**DEPARTMENT OF TRANSPORTATION
STATE OF GEORGIA**

SUBJECT: IMPLEMENTATION OF VALUE ENGINEERING STUDY ALTERNATIVES

SUBJECT: Value Engineering Study Responses

**Re: SR 1/US 27 from Veterans Memorial Hwy to
Old Dalton Road
STP00-0017-03(064) PI 631480
Floyd County, GA**

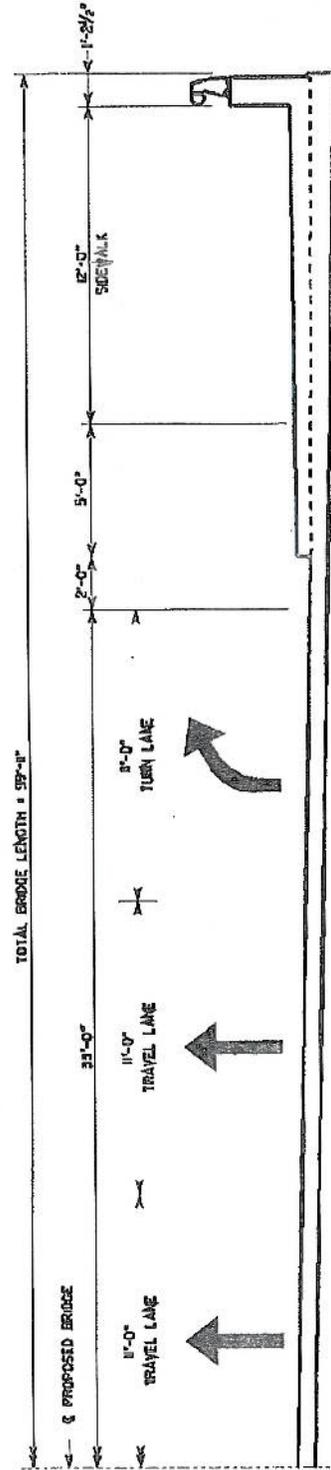
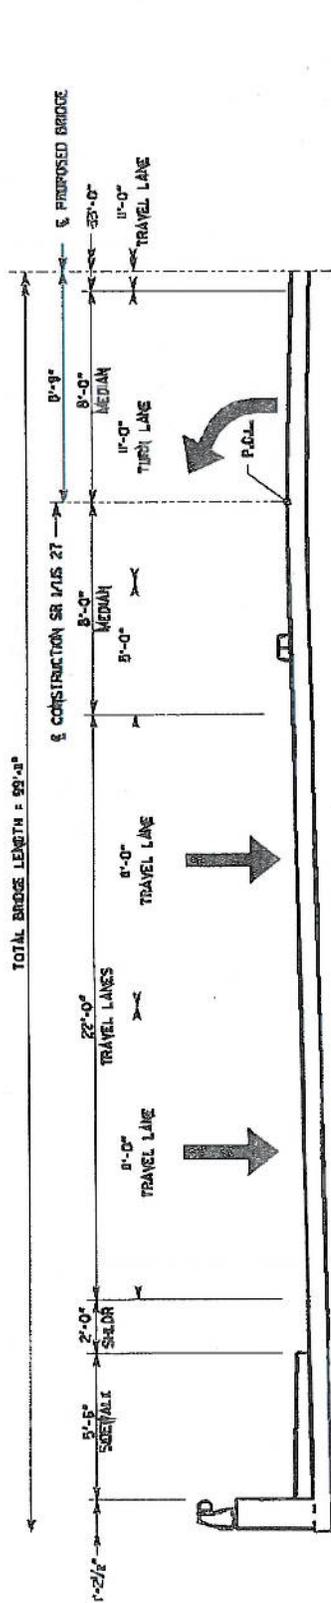
B-5: Eliminate the utility strip from the bridge width.

VE Team Estimated Savings - \$147,000.

Response: No, we will not implement.

Actually, this 5 ft strip of grass between the back of the curb and edge of the multi-use path is not a utility strip, but is intended to provide separation between pedestrians and motorists. During the revision of the final concept report, the roadway typical section was applied to the

bridge section. The Georgia Department of Transportation Pedestrian and Streetscape Guide states that AASHTO requires a 5 feet minimum horizontal separation from motor vehicle traffic.
